Subject: Task 11: Response Letter to DMS review comments regarding the Draft Year 5 Monitoring Report for the St. Clair Creek Restoration Project (#95015)  
Beaufort County, North Carolina, Cape Fear Basin – CU#03020104  
DMS No. 95015, Baker No. 125116

# **St. Clair Creek Restoration Project Year 5 FINAL Monitoring Report**

DMS Project ID No. 95015

**Figure 2**  
**Current Conditions Plan View: MY5**  
**St. Clair Creek Site**  
**Beaufort County, NC**

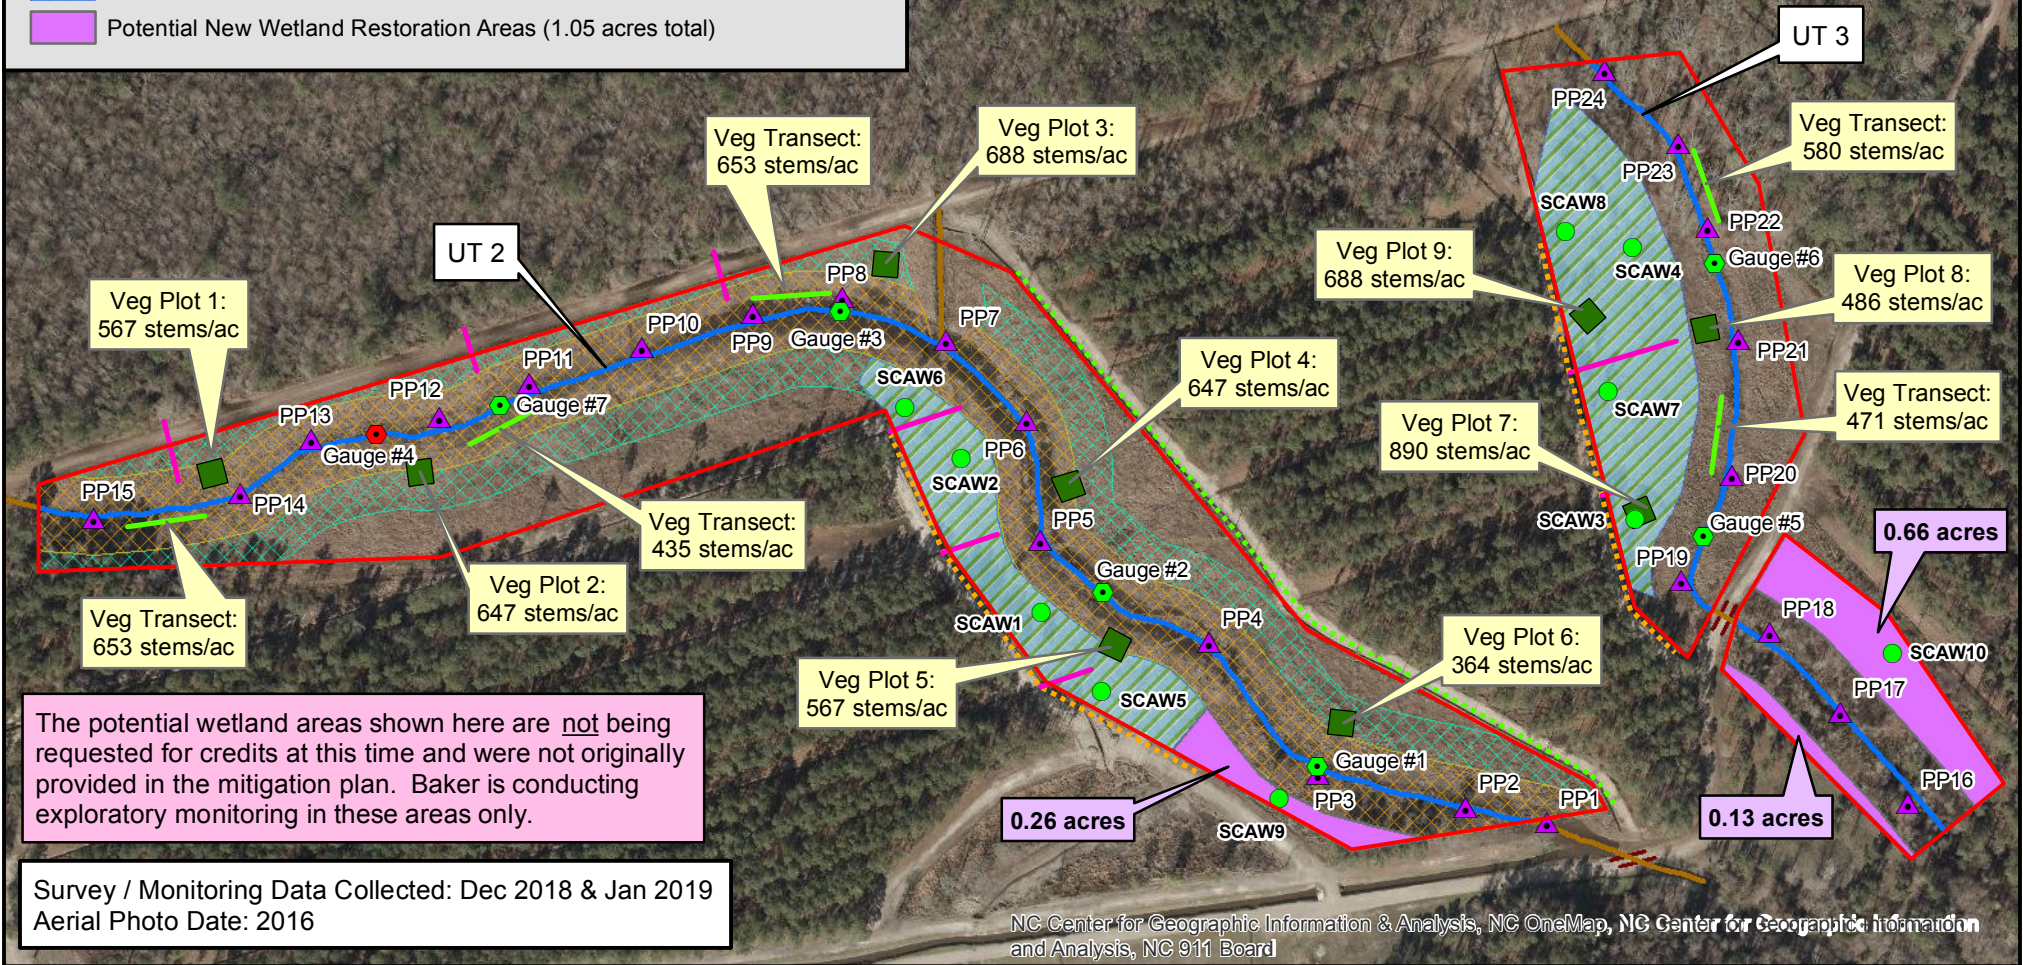
5. Appendix B, Figure 2: In the figure included in the hardcopy of the report, the colors denoting Flow Gauge Meeting Criteria and Not Meeting Criteria are the same in both the legend and on the map. Please make sure they are different when the final is submitted. Note: the pdf copy submitted electronically does not have this problem.

**Response: We apologize for the misleading and confusing printed color error. This does not appear in our GIS files nor in our pdf copies either and we will make sure that it does not print incorrectly again for the final hardcopies.**

### St. Clair Creek Flow Gauge SCFL4 (Upstream UT2)

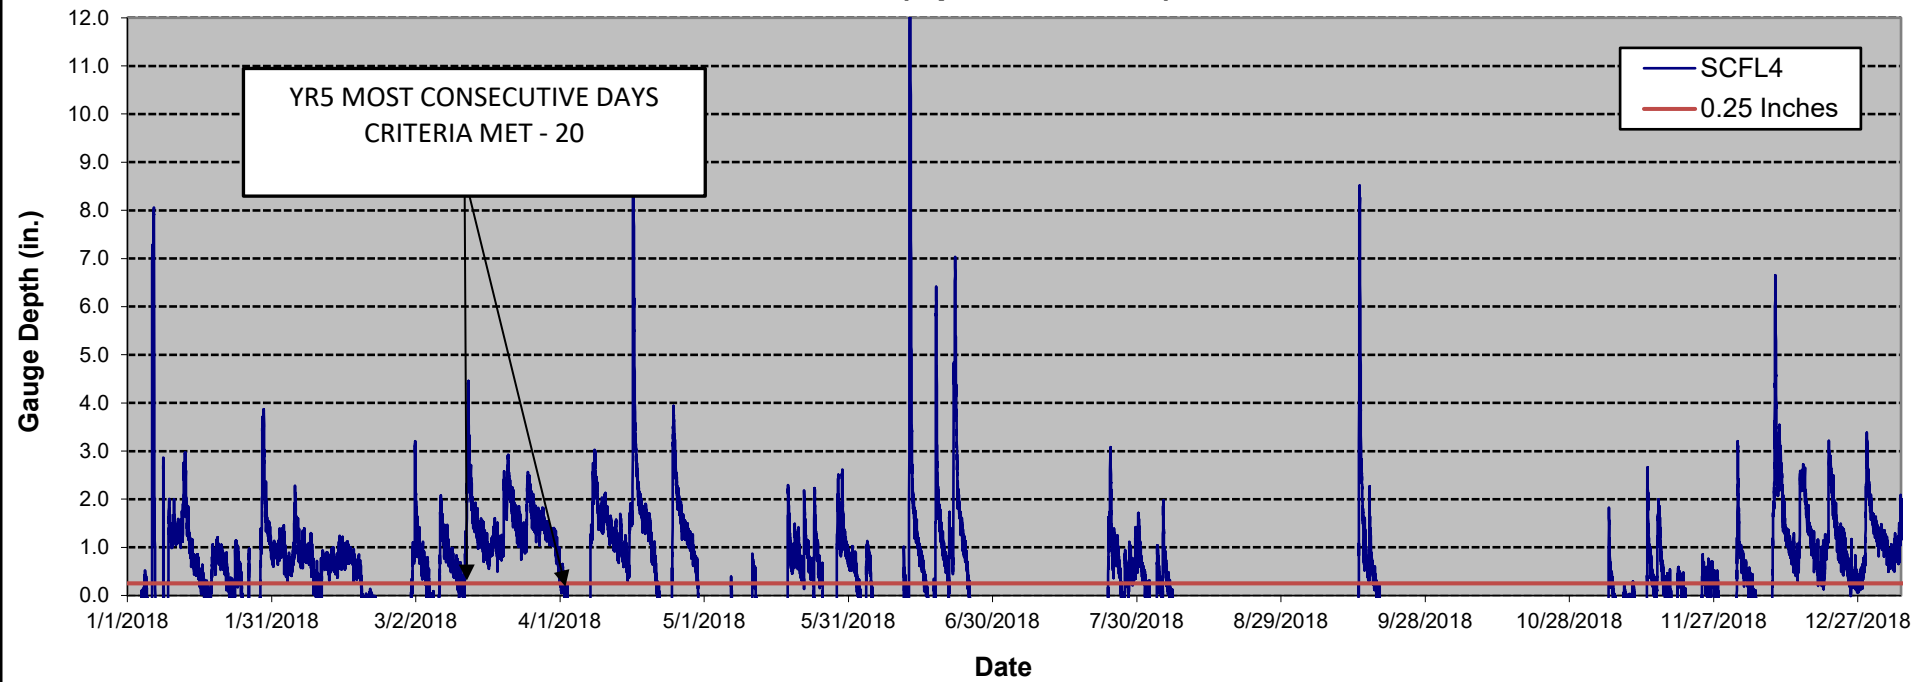
3. Section 1.0, page 2 and Section 2.1.1, page 3: The report discusses the failure of flow gauge SCFL#4. This gauge has failed 4 out of 5 monitoring years, though barely missing the 30 consecutive days of flow requirement in Year 4 (29 days). Based on this, DMS has the following comments/concerns:

- a. Clarify reason/potential reason for flow gauge SCFL#4 not meeting 30 consecutive days of flow requirements, especially given that this area was impacted by two hurricanes and a wetter than normal summer and fall. Baker needs to be prepared to discuss at the upcoming credit release meeting.

- b. DMS believes stream credits are at risk from SCFL#4 to the top of UT2 ( $\pm 466$  lf/credit as measured using GIS) at a minimum. This would put Baker 192 credits below contract for stream which would reduce payments from this point forward to avoid overpayment by DMS. Please concur or offer your explanation for why these are not at risk.

**Response: Baker certainly understands the concern from not meeting the success criteria during such an overall wet year, but the flow gauges on site have always met the criteria in the late winter to early spring when the water table is highest and is contributing some base flow that is supplemented with the rain. In the summer and through the fall, the evapotranspiration rates are very high, the water table plummets, and there is no base flow present – it’s all rainfall driven. And it is difficult to achieve 30-days continuous flow on just rainfall alone. So all of the rain from this past fall and winter did not actually contribute much to the continuous flow requirement. Because of that rain we did observe more *total* days of flow on site, just not continuous and unbroken flow. Hurricane Matthew also dropped an extreme amount of rain on site in 2016 without triggering 30-days of continuous flow. Yet all flow gauges on site did meet the criteria earlier that same year in the winter/spring with a high water table and modest rainfall.**

**Response: While Baker understands the concern regarding flow at the top of UT2, we believe that it is nevertheless premature to reduce the expected credits and resulting payment for the project at this time. Flow gauge SCFL#4 need only meet its success criteria once more in the upcoming two monitoring years to have fulfilled its requirement as stated in the mitigation plan (i.e. meeting the success criteria twice in separate years during the monitoring period). It has already met once and come very close on three other occasions.**

**Figure 5. Observed Rainfall versus Historic Average  
St. Clair Restoration Project (DMS No. 95015) MY5 2018**

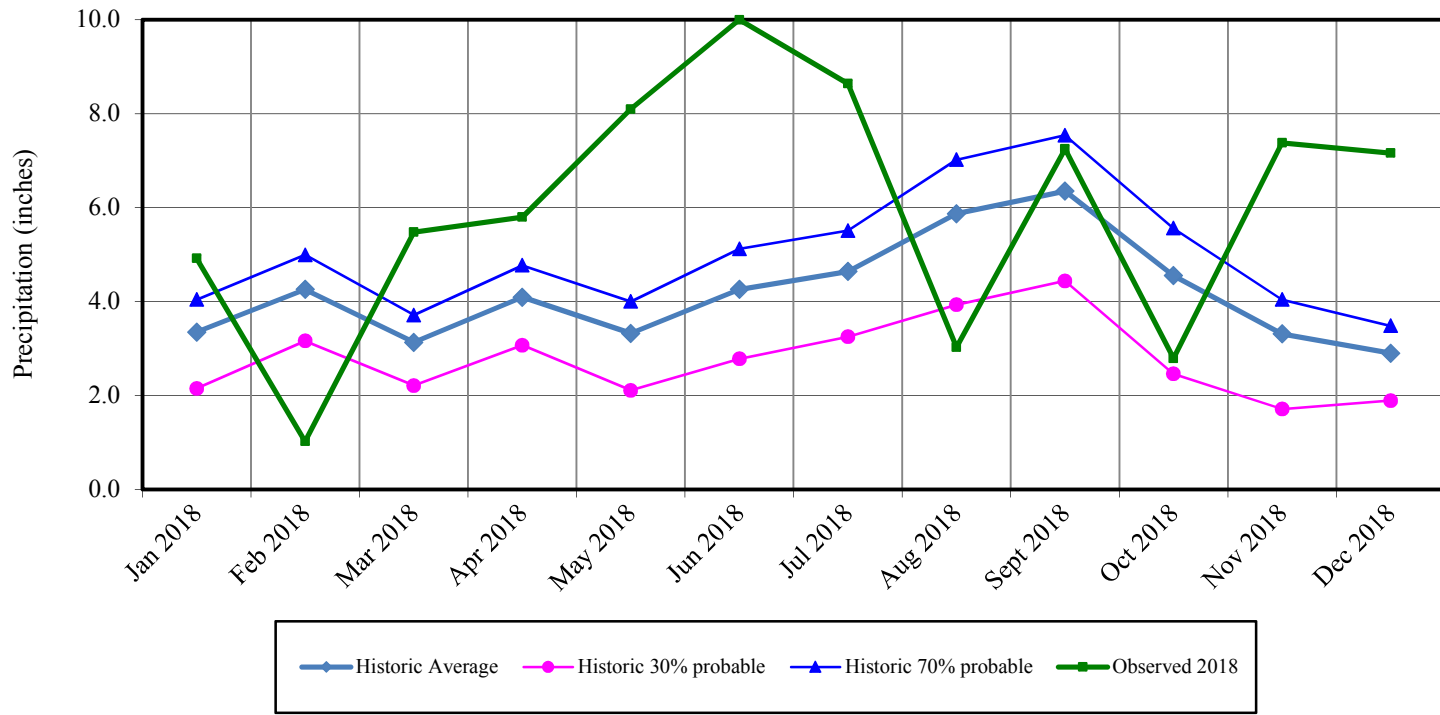
- Appendix D: Flow graphs for SCFL 2, 3, 5, 5, 6 and 7 as well as Figure 5 (rainfall comparison) are missing from the hardcopy of the report. Please make sure to include them in the final report. Note: these graphs and Figure 5 were included in the electronic submittal and pdf copy.

**Response: We apologize for the oversight in failing to include printed copies of all of the flow graphs and rainfall figures in the draft hardcopy report. We will make sure that they are all included in the final reports.**
